TVA-BFN-TS-443

**BROWNS FERRY NUCLEAR PLANT (BFN) UNIT 1 - TECHNICAL SPECIFICATIONS (TS) CHANGE TS-443 - OSCILLATION POWER RANGE MONITOR (OPRM)**

TVA EVALUATION OF PROPOSED CHANGE

Figure 3.4.1-1  
THERMAL POWER VERSUS CORE FLOW STABILITY REGIONS

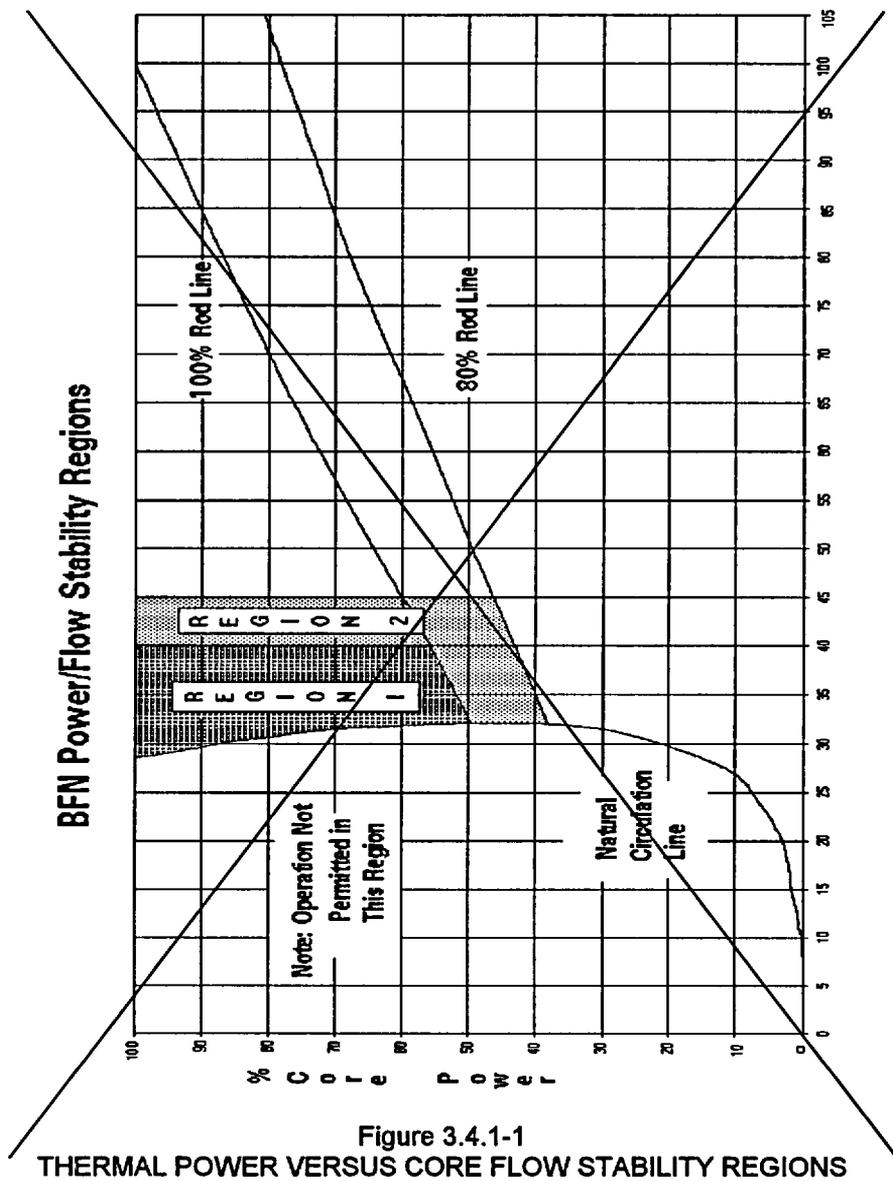
Restrictions related to operation in the thermal-hydraulic instability regions are no longer required. Therefore, Figure 3.4.1-1, *Thermal Power Versus Core Flow Stability Regions*, is being deleted in its entirety.

The deleted figure is shown below:

Note that the proposed deletion of Figure 3.4.1-1 was previously proposed as part of TS-431, *Extended Power Uprate Operation* (Reference 1). If TS-431 is approved prior to this proposed TS change, then deletion of Figure 3.4.1-1 will no longer be necessary. If this proposed TS change is approved before TS-431, then deletion of Figure 3.4.1-1 will no longer be required as part of TS-431.

10. As discussed in 5 above, restrictions related to operation in the thermal-hydraulic stability region are no longer required. Therefore, this figure is being deleted.
